APPLICATION NO.	FILING DATE	FIRST NAMED INVENTOR	ATTORNEY DOCKET NO.	CONFIRMATION NO.
10/598,954	04/16/2007	Augusto Ribolzi	IT20040007 US	2515
WHIRLPOOL PATENTS COMPANY - MD 0750 500 RENAISSANCE DRIVE - SUITE 102			EXAMINER	
			SULLIVAN, MATTHEW J	
ST. JOSEPH, MI 49085			ART UNIT	PAPER NUMBER
			3677	
			MAIL DATE	DELIVERY MODE
			10/20/2008	PAPER

DETAILED ACTION

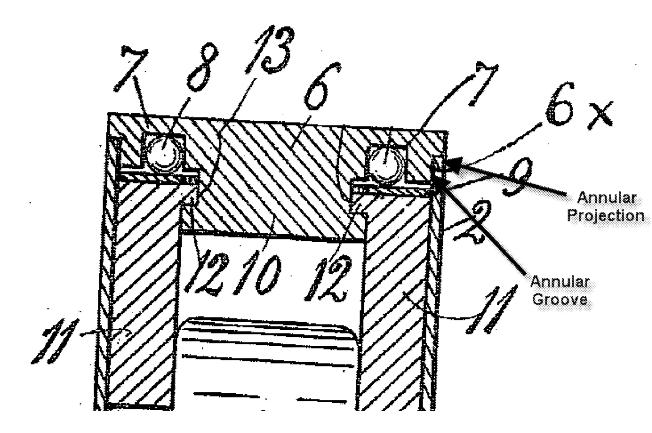
Regarding **Claim 11**, Cobb further teaches a rotary element (2, 9, 11, 14, 15) and a stationary element (6). Cobb further describes what is essentially an elastic snap-fit connection (see Col 1, Lines 44-50) connecting the stationary and rotary elements.

Regarding **Claim 12**, Cobb teaches the snap fit connection comprising an annular groove (comprising a step) and an annular projection received in that groove (see below).
